# Access Compliance Report

## Public Rights-of-Way

Intersection ID: 31416	Main Street: BRAWER_FARM_DR	Cross Street: IRON_BRIGADE_LN	Location: E
ADA ID: BD99970B2391	Ramp Type: PerpDiag	Initial Pass/Fail: Fail	Overall Compliance: No
		Severity Score: 22.5

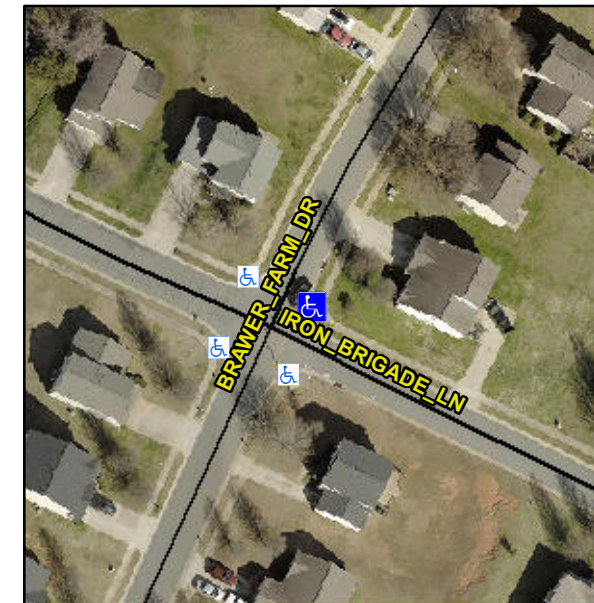
**Not Found, R304.5.1, R304.2.2, R304.5.3**

Compliance	Description	Data	Compliance	Description	Data
N/A	Ramp Length (in)	48.0	No	Ramp Slope (%)	8.5
No	Ramp Width (in)	46.0	No	Ramp XSlope (%)	4.7
N/A	Flare Type LT	N/A	N/A	Flare Type RT	N/A
N/A	Flare Slope LT (%)	N/A	N/A	Flare Slope RT (%)	N/A
N/A	Flare Traversable LT?	N/A	N/A	Flare Traversable RT?	N/A
N/A	Landing Length (in)	N/A	N/A	DWS Provided?	N/A
N/A	Landing Width (in)	N/A	N/A	DWS Contrast?	N/A
N/A	Landing Slope (%)	N/A	N/A	DWS Length (in)	N/A
N/A	Landing X Slope (%)	N/A	N/A	DWS Full Width?	N/A
N/A	Landing Curb? (Y/N)	N/A	N/A	DWS Offset (in)	N/A
N/A	Shared Landing?	N/A			
N/A	Gutter Ponding?	N/A	N/A	Gutter Slope (%)	N/A
N/A	Gutter Lip Ht (in)	0.5	N/A	Gutter X Slope (%)	N/A
N/A	Painted X Walk1?	No	N/A	Painted X Walk2?	No
	X Walk 1 Direction	To N		X Walk 2 Direction	To S
N/A	X Walk 1 Width (in)	N/A	N/A	X Walk 2 Width (in)	N/A
	X Walk 1 Slope (%)	0.6		X Walk 2 Slope (%)	1.6
	X Walk 1 X Slope (%)	3.0		X Walk 2 X Slope (%)	2.3

**Remove & Replace Curb Ramp With Two New Directional Ramps or Equivalent.**
